### Federal Motor Vehicle Safety Standards; Platform Lifts for Motor Vehicles; Platform Lift Installations in Motor Vehicles

**ACTION:** Final rule.

**SUMMARY:** This document adopts amendments to the Federal motor vehicle safety standards on platform lift systems for motor vehicles. The purpose of these standards is to prevent injuries and fatalities during lift operation. NHTSA believes it is necessary to revise the lighting requirements for lift controls; the location requirements, performance requirements, and test specifications for threshold warning signals; the wheelchair retention device and inner roll stop tests; and the lighting requirements for public use lifts. This notice also discusses a November 3, 2005 interpretation clarifying specific procedures that are performed as part of the threshold warning signal test.

**FIGURE 2**

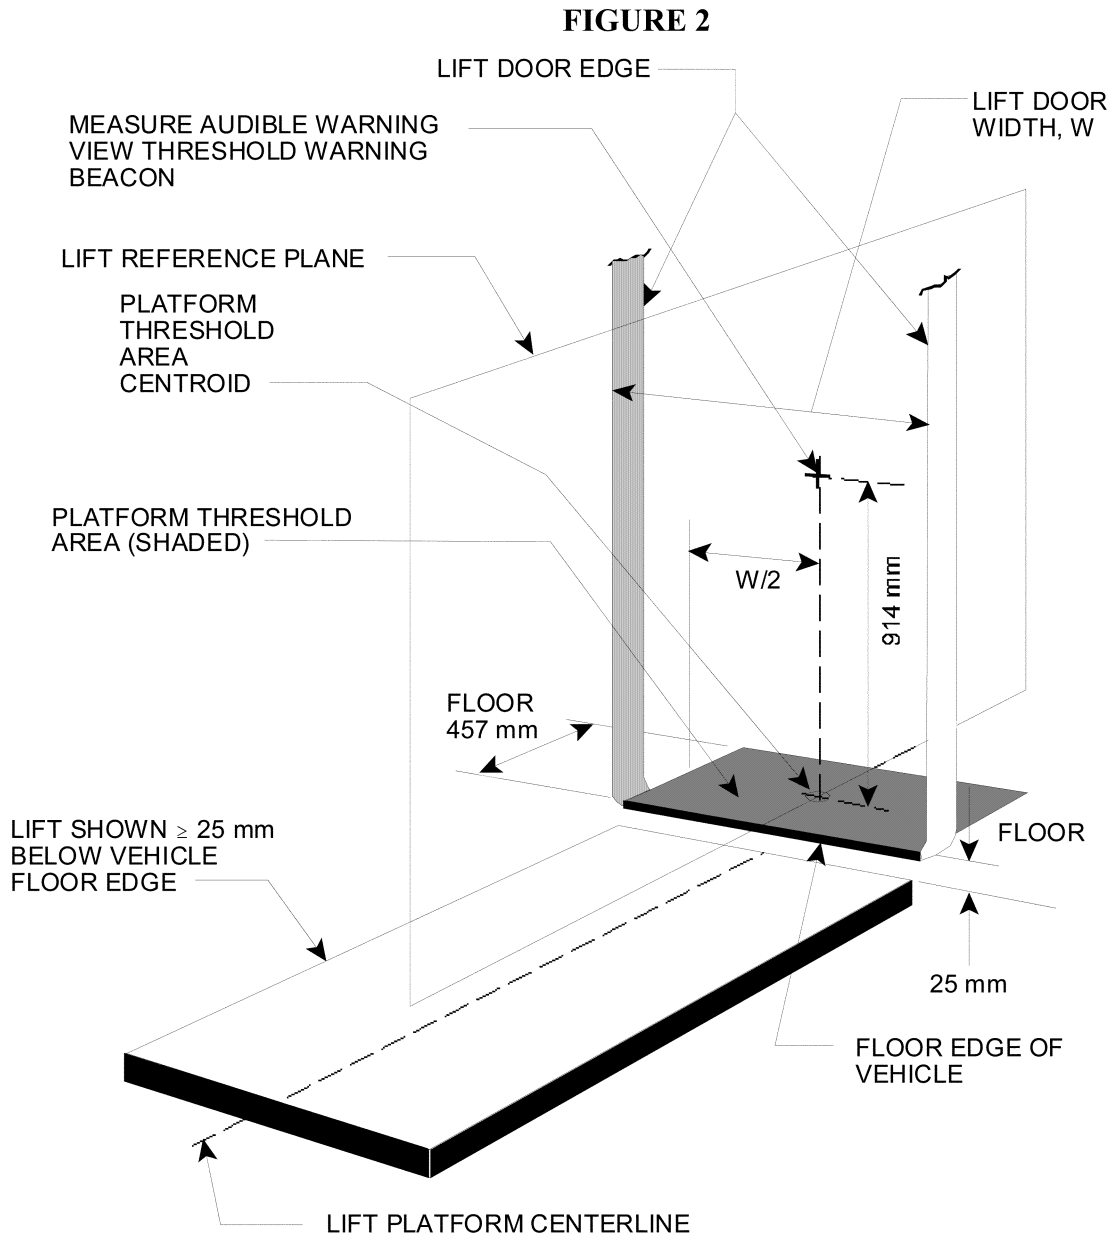
NHTSA also proposed a correction to Figure 2 of FMVSS No. 403. Currently, the height of the measurement point from which the intensity of the threshold audible warning is measured is identified as 919 mm. The proposed amendment would replace that distance with the correct measurement point of 914 mm (3 feet).

candela, a frequency from 1 to 2 Hz, and must be located within the interior of the vehicle such that it is visible from a point 914 mm (3 ft) above the center of the threshold area (see Figure 2) wherever the lift is installed and with any configuration of the vehicle interior.

S6.1.6 The intensity of the audible warning and visibility of the visual warning required by S6.1.2 and S6.1.3 is measured/observed at a location 914 mm (3 ft) above the center of the platform threshold area. (See Figure 2).
